ENGINEERING INSTRUCTIONS -- FIFTH AVENUE

ENGINEERING INSTRUCTION - 16TH STREET

ERRATA
FOR
INSTRUCTION MANUAL
COMMUNICATIONS TRANSCEIVER
MODEL SR-2000

NUMBER C-380

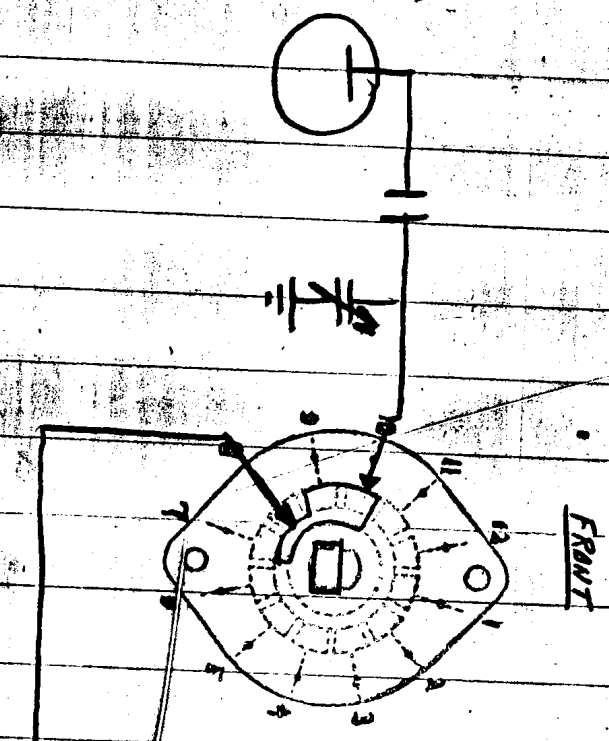
REASON: To improve 6MC I.F. feed thru. To turn off 100KC marker in transmit. To prevent contact arcing on 40M Band.

1. Disconnect coax lead (Rcvr ant lead) from band switch wafer "B". Connect a 1½" long green lead to the Band switch lug in place of the coax. Mount trap coil (050-003467) on spade bolt of the antenna coil can next to 100KC crystal socket (Y1). Do not remove spade bolt Nvt. The trap coil has a threaded mounting bushing. Rotate the trap coil until mounted firmly, too much pressure may crack the coil form. Connect 1800 MMF Dur-Mica capacitor (493-310182-124) across coil lugs. Attach 1½" long green lead to coil lug with color dot (Start of winding). Attach coax lead (Rcvr ant lead) to other lug, Finish of winding).

2. Change R8 from 2200 ohm ½ W. (451-252222) to 4700 ohm ½W (451-252472) located between band switch wafer "F" and shield plate, (Ground).
 3. Disconnect lug #8 of VII from ground. Add a .02 +80 -20% 500V Disc (047-100242) between lug #8 of VII and ground. Connect a white/red wire from lug #8 to terminal #3 of vox relay (K2).

4. On band switch wafer "J" connect lugs #2 and #3 together with a #14 GA. bare tinned wire jumper.
- Walter*
